Amendments to the Drawings:

REMARKS/ARGUMENTS

Fig. 1

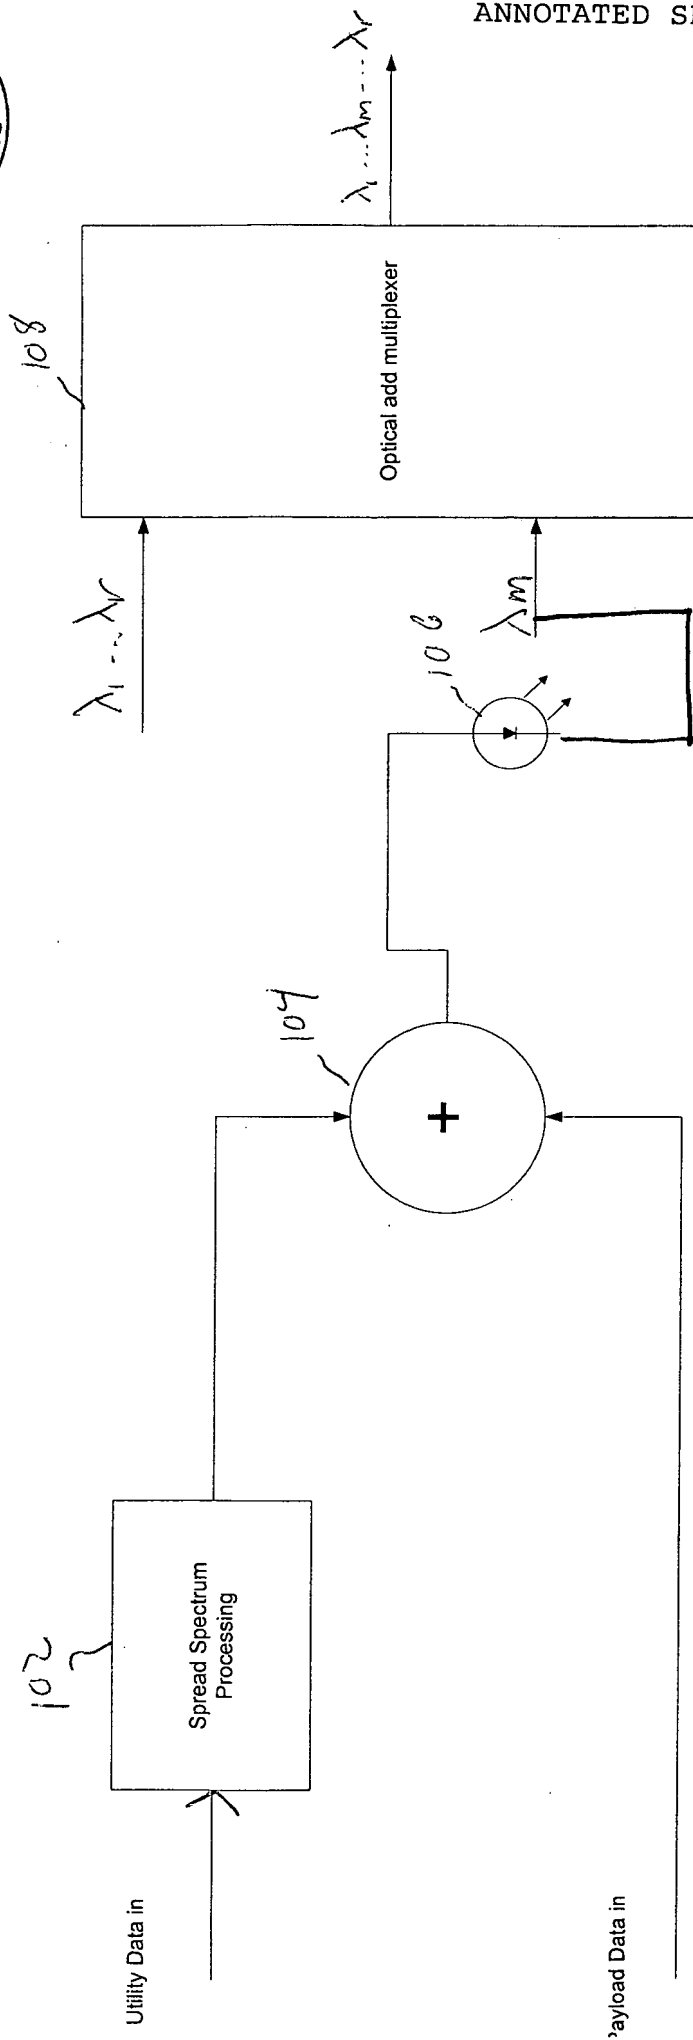
Furthermore, a set of replacement drawings is hereby submitted to replace the original drawings for Figs. 1-5. The new drawings replace the reference numerals which were marked by hand and ensure that the drawings are correctly sized. Some minor changes were also made for aesthetic purposes. Also, in Fig. 1 a connection has been made to fill the inadvertent gap between the laser 106 and the optical add multiplexer 108.
